NH PUC Docket DE 16-442:

Petition of PSNH d/b/a Eversource Energy to Construct and Maintain
Electric Lines, Neutral Wire and Fiber Optic Cable Over/Across the
Public Lands Owned by the State of NH
in Towns of Durham and Newington

SUMMARY
Revisions between Originally Submitted Petition
And Revised Engineering Design

Changes to Original Petition

SEACOAST RELIABILITY PROJECT
 STRUCTURES #46-56
 STATE OF NH PROPERTY CROSSING
 TOWN: DURHAM
 TRANSMISSION LINE: F107
 MILE NO: --
 DISCIPLINE/SHT NO: --
 SHEET 1 OF 2
 F10799002

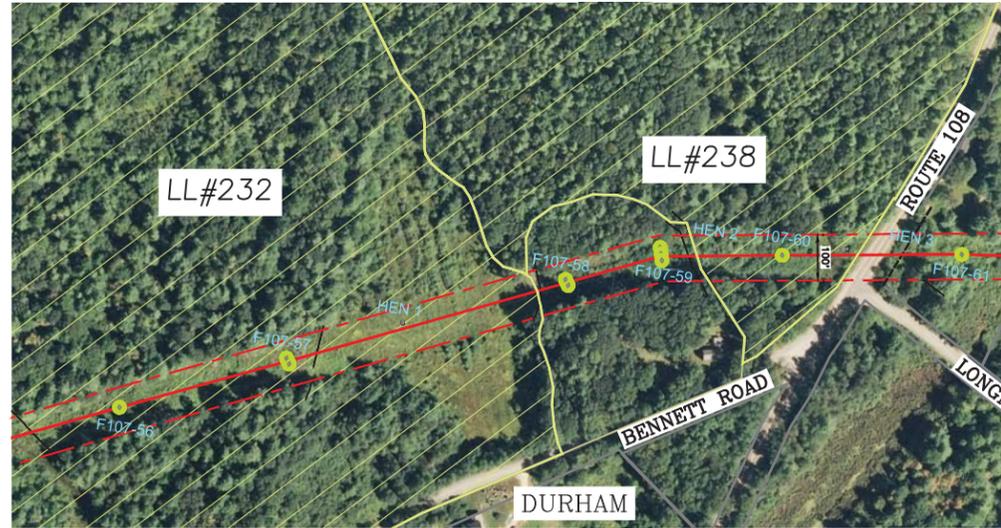
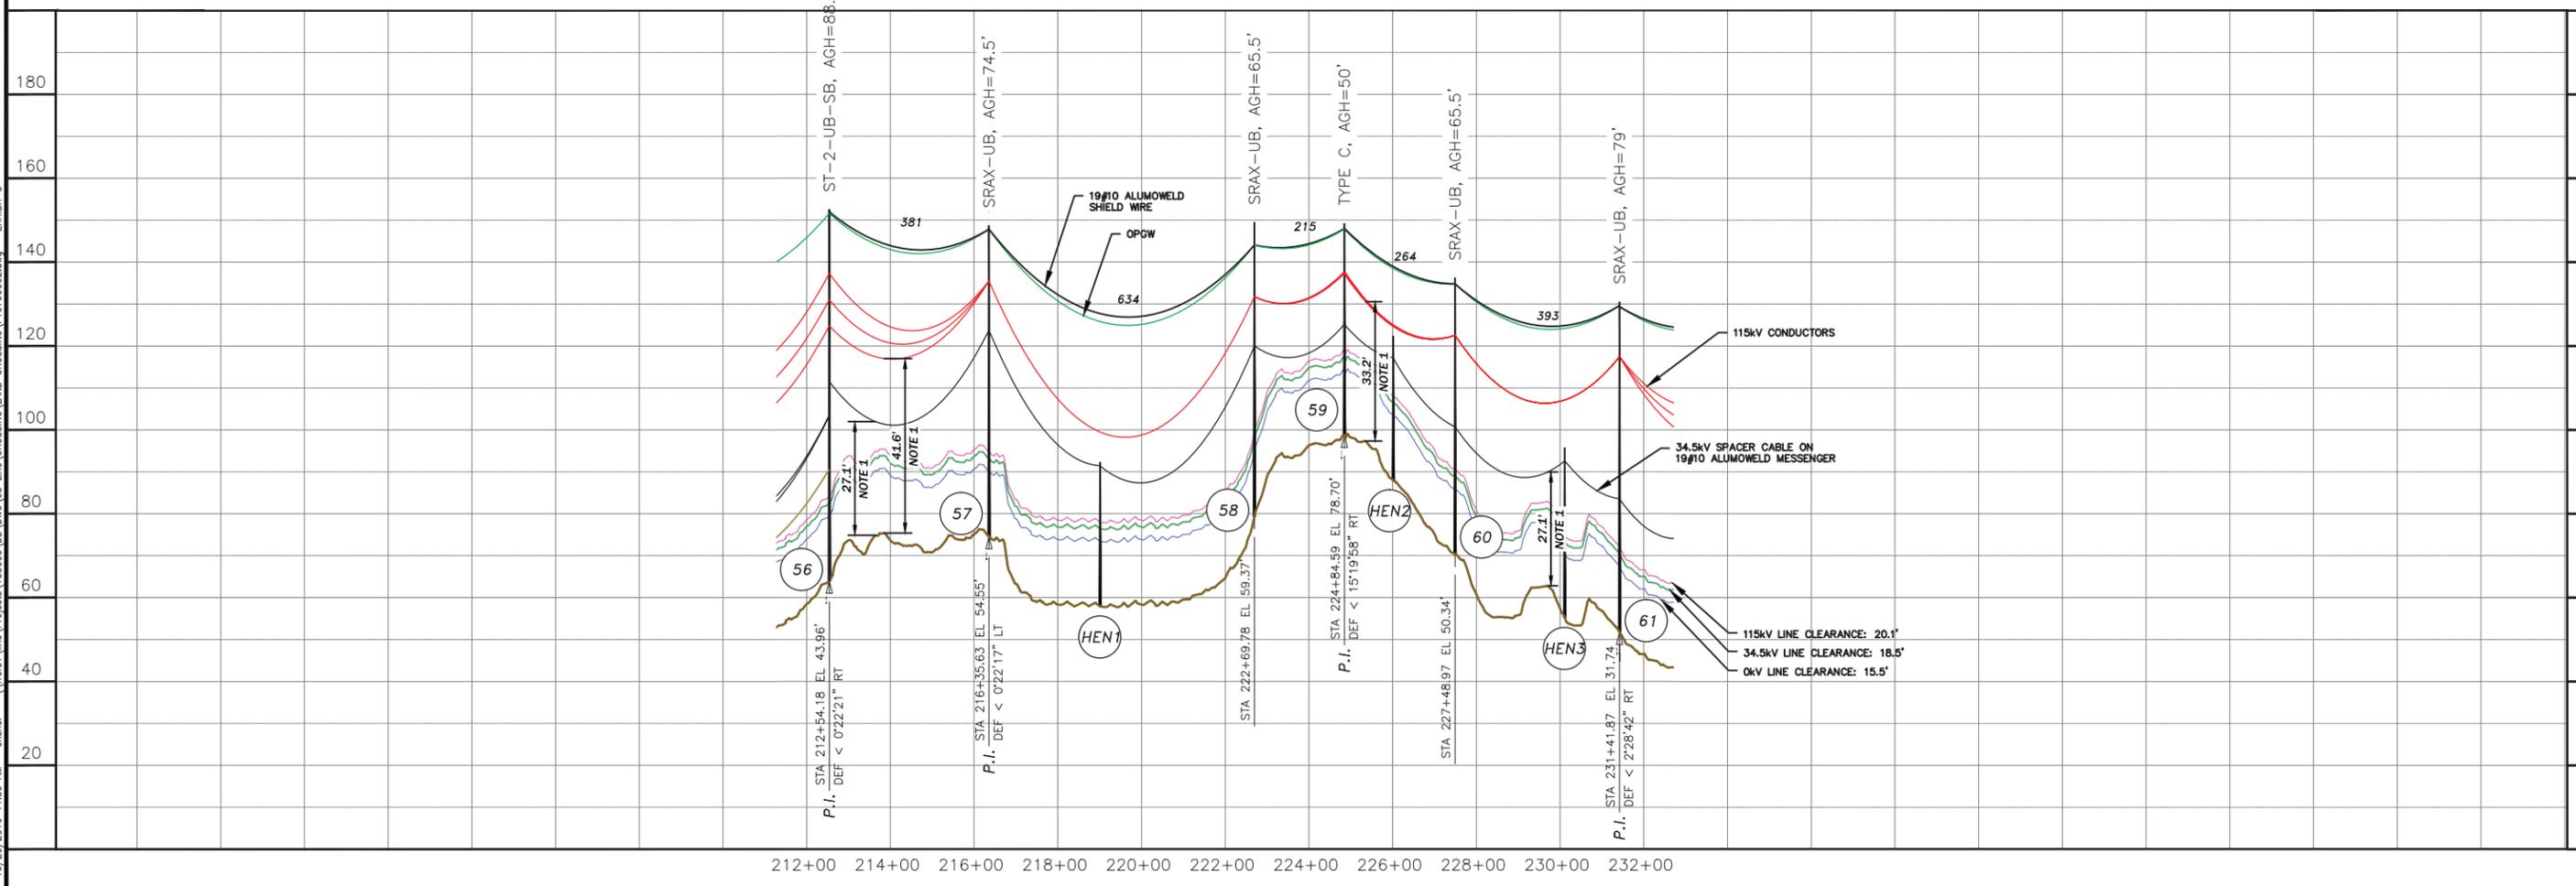
1. Paragraph #1- Revised Drawing number F10799002 (Exhibits 2 and 3) has been supplied. No changes to location plan (Exhibit 1).
2. Paragraph #3- **Change** “WT-1-UB,” “WT-2-UB” and “RAX-UB” to “ST-1-UB”, “ST-2-UB” and “SRAX-UB” respectively.
3. Paragraph #3 Bullet 1- **Change** “7.5-15 feet” to “7.5-13 feet”
4. Paragraph #3 Bullet 1- **Change** “nine inches” to “six inches”
5. Paragraph #3 Bullet 1- **Change** “7.5 feet” to “7.0 feet”
6. Paragraph #3 Bullet 2- **Change** “7.5-15.5 feet” to “7.5-12.5 feet”
7. Paragraph #3 Bullet 2- **Change** “nine inches” to “six inches”
8. Paragraph #3 Bullet 2- **Change** “0-2.5 feet” to “0-5 feet”
9. Paragraph #3 Bullet 3- **Change** “nine inches” to “six inches”

10. Paragraph #3 Bullet 3- **Change** “15 feet” to “11.75 feet”

11. Table 1 Column 3- **Change** 15.5 feet to 18 feet

1. Paragraph #1- Revised Drawing number F10799002 (Exhibit 3) has been supplied. No changes to location plan (Exhibit 1).
2. Paragraph #3- **Change** “RAX-UB” to “SRAX-UB”.
3. Paragraph #3 - **Change** “nine inches” to “six inches”
4. Paragraph #3 - **Change** “15 feet” to “11.75 feet”
5. Table 1 Column 3- **Change** 15.5 feet to 18 feet
6. Paragraph #5- **Change** “water” to “land”
7. **Replace** Table 3 with revised table below

SHEET 1 OF 1
F10799004

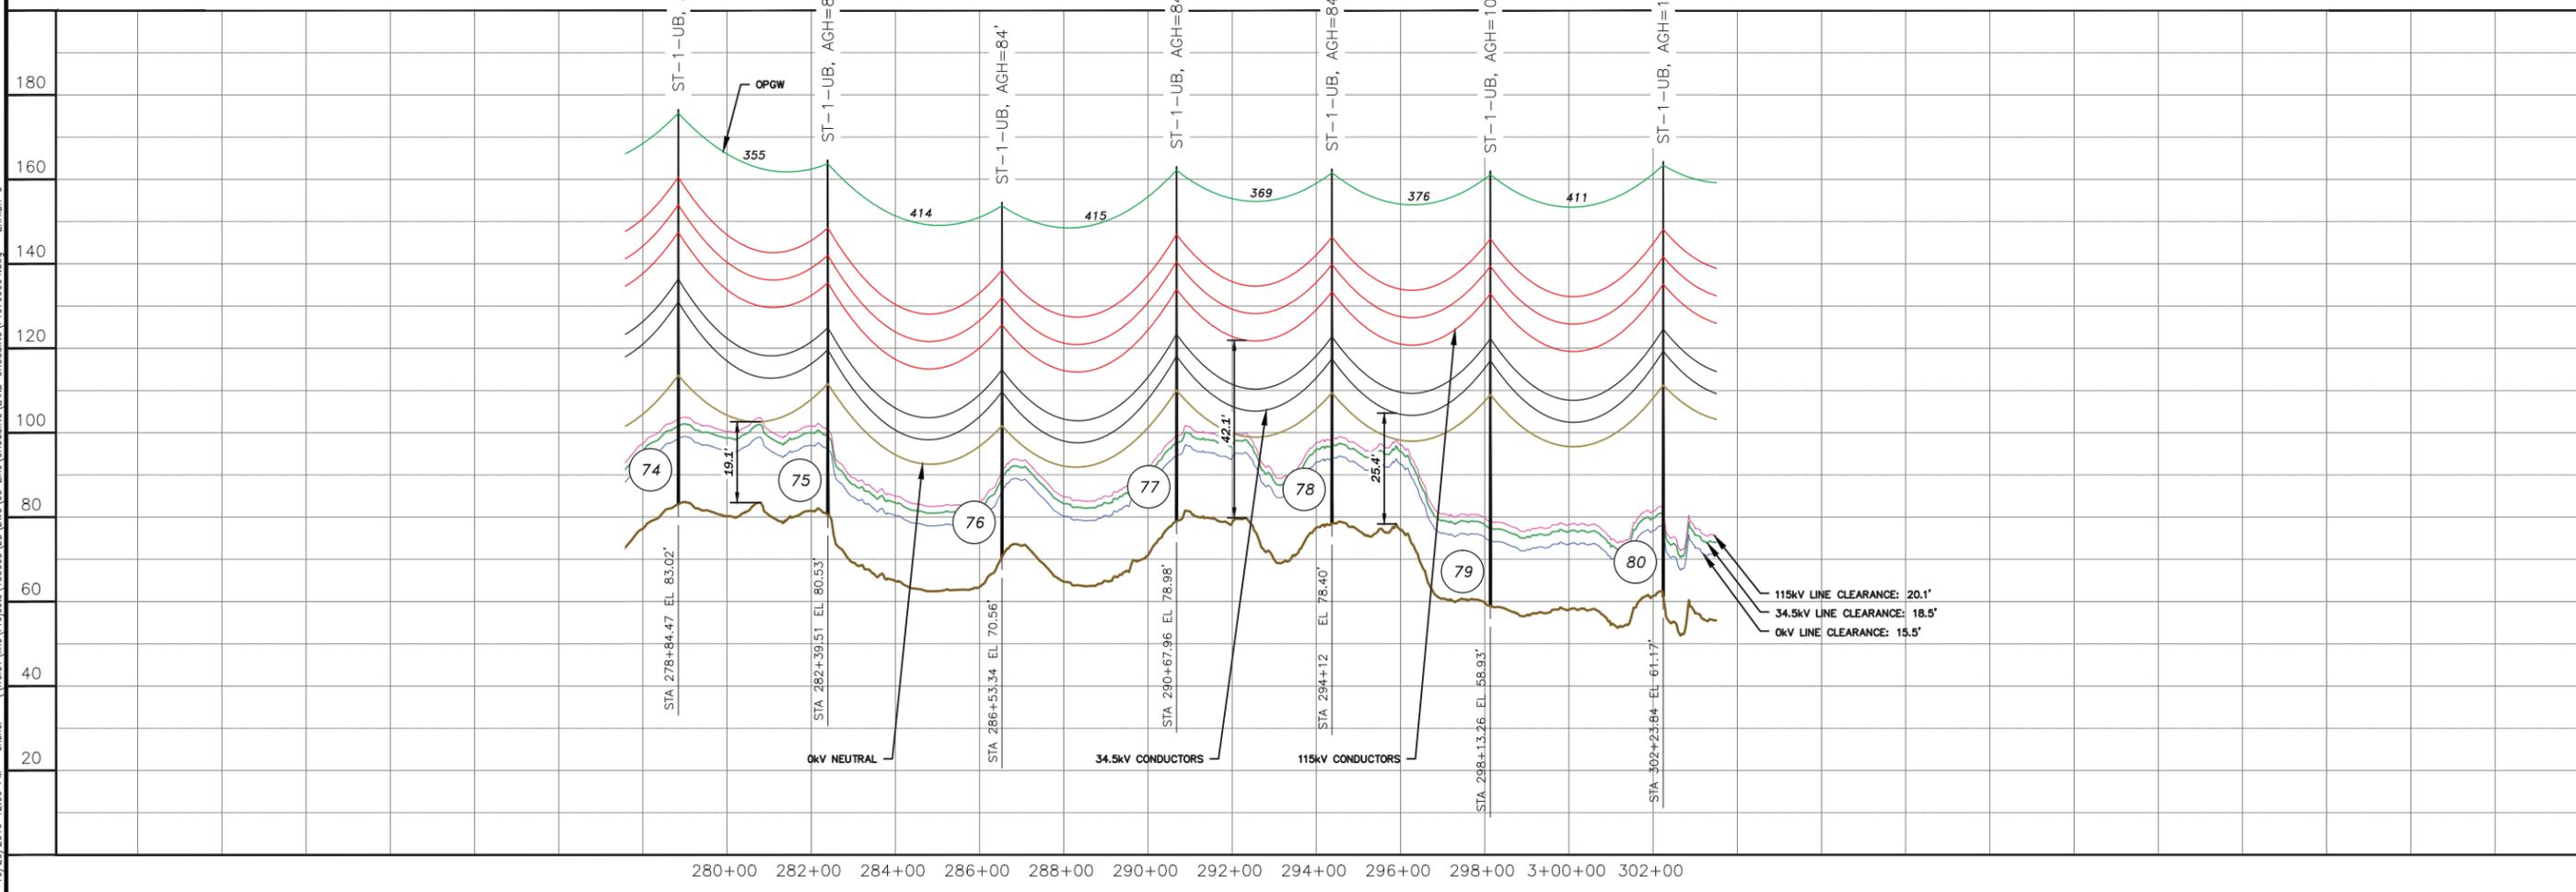
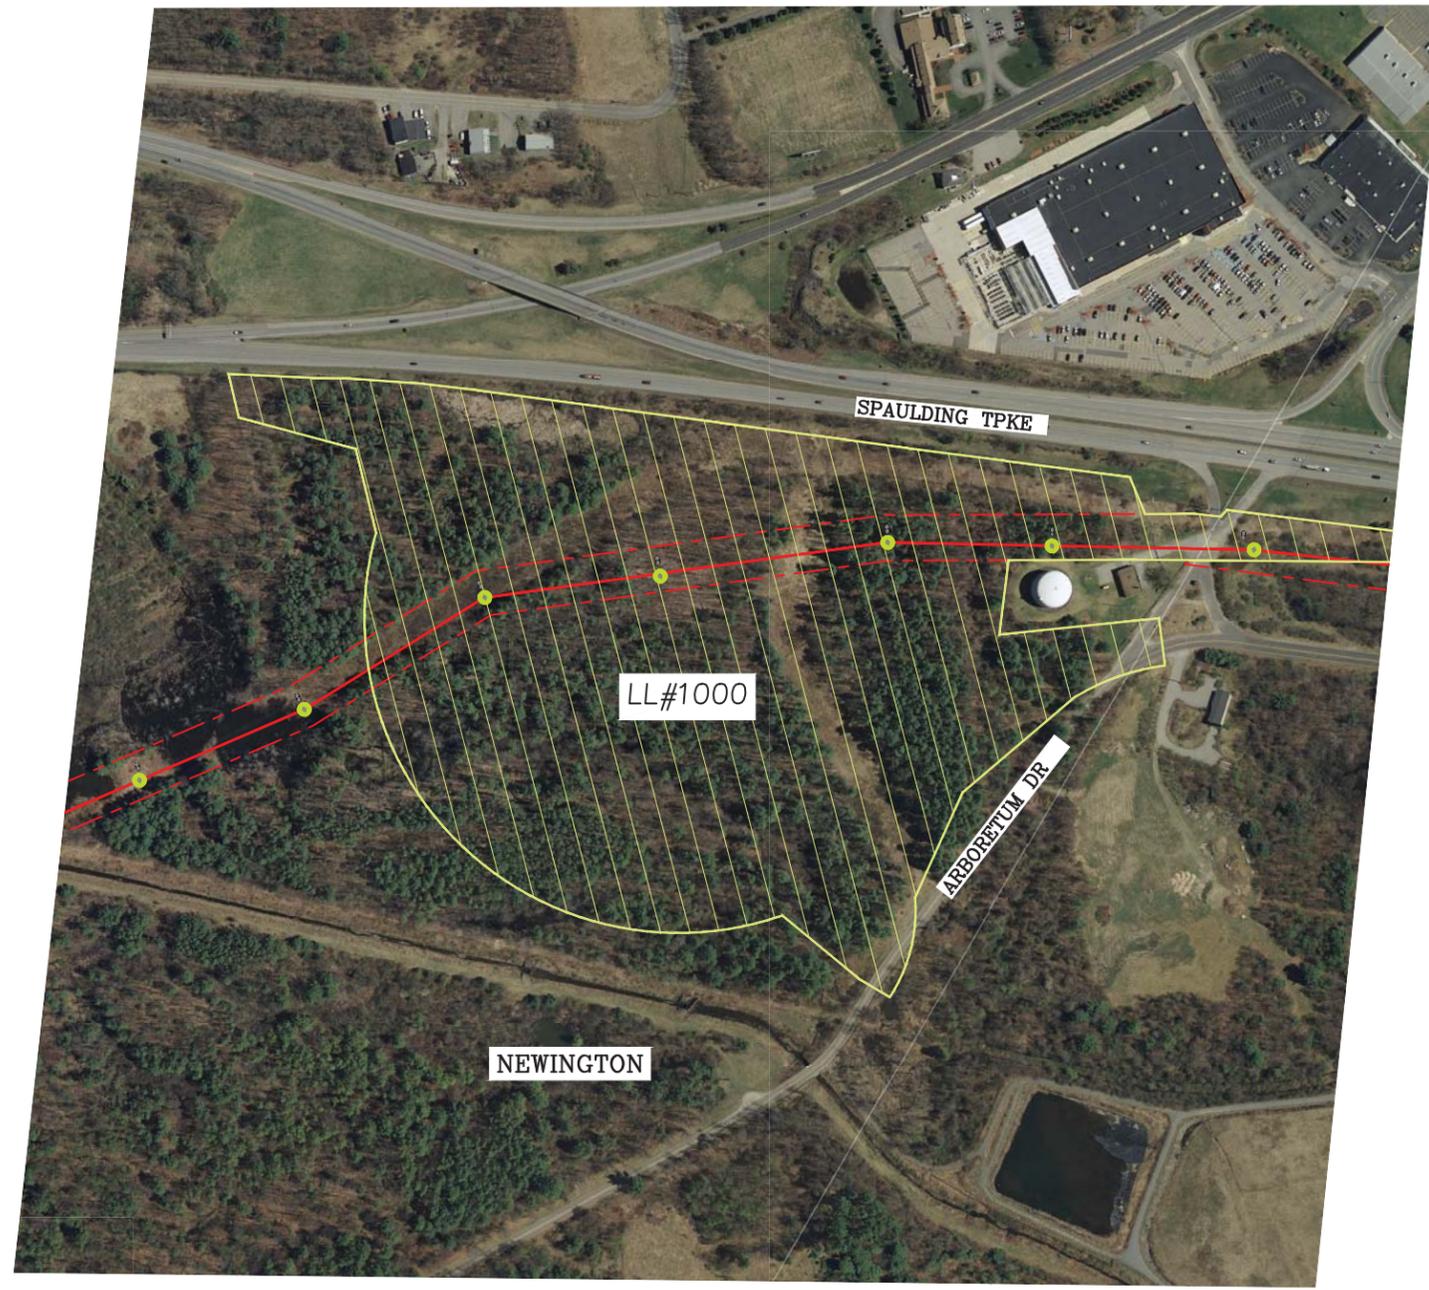
1. Paragraph #1- Revised Drawing number F10799004 (Exhibit 5) has been supplied. No changes to location plan (Exhibit 4).
2. Paragraph #3- **Change** “WT-1-UB to “ST-1-UB”.
3. Paragraph #3 - **Change** “7.5-15 feet” to “7.5-13 feet”
4. Paragraph #3 - **Change** “nine inches” to “six inches”
5. Paragraph #3 - **Change** “7.5 feet” to “7.0 feet”
6. Table 1 Column 3- **Change** 15.5 feet to 18 feet
7. Paragraph #5- **Change** “water” to “land”
8. **Replace** Table 3 with revised table below

DES: ---	CHKOUTS: ---
DRW: CTS	APR: ---
TOWN: NEWINGTON	
TRANSMISSION LINE: F107	
MILE NO: ---	
DISCIPLINE/SHT NO: ---	
SHEET 1 OF 1	
F10799006

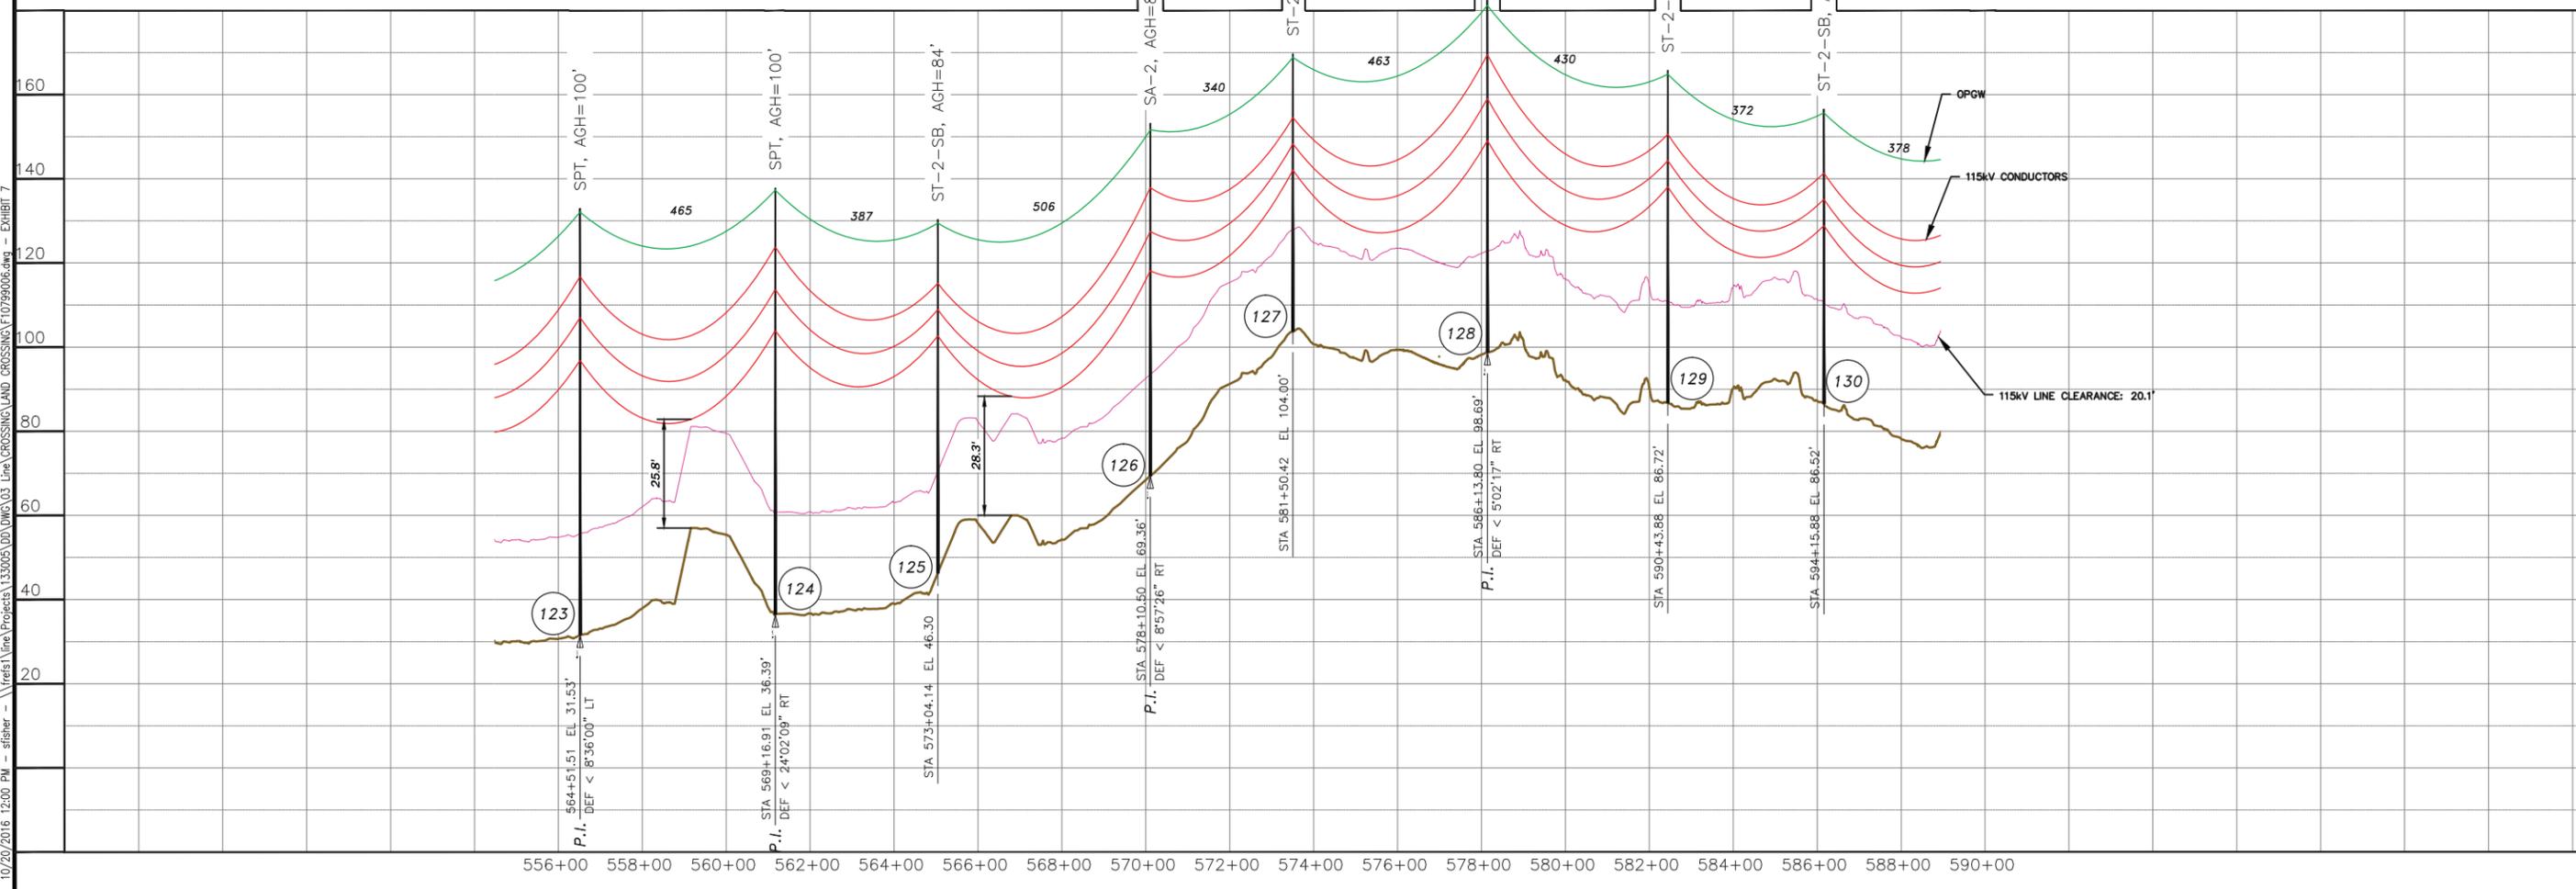
1. Paragraph #1- Revised Drawing number F10799006 (Exhibit 7) has been supplied. No changes to location plan (Exhibit 6).
2. Paragraph #3- **Change** “WT-2-UB”, “SPRA-BP” and “WA-2” to “ST-2-UB”, “SPT” and “SA-2” respectively.
3. Paragraph #3 - **Change** “7-15.5 feet” to “7-12.5 feet”
4. Paragraph #3 - **Change** “nine inches” to “six inches”
5. Paragraph #3 - **Change** “ten feet” to “10.25 feet”
6. Table 1 Column 3- **Change** 15.5 feet to 18 feet
7. Paragraph #5- **Change** “water” to “land”
8. **Replace** Table 3 with revised table below
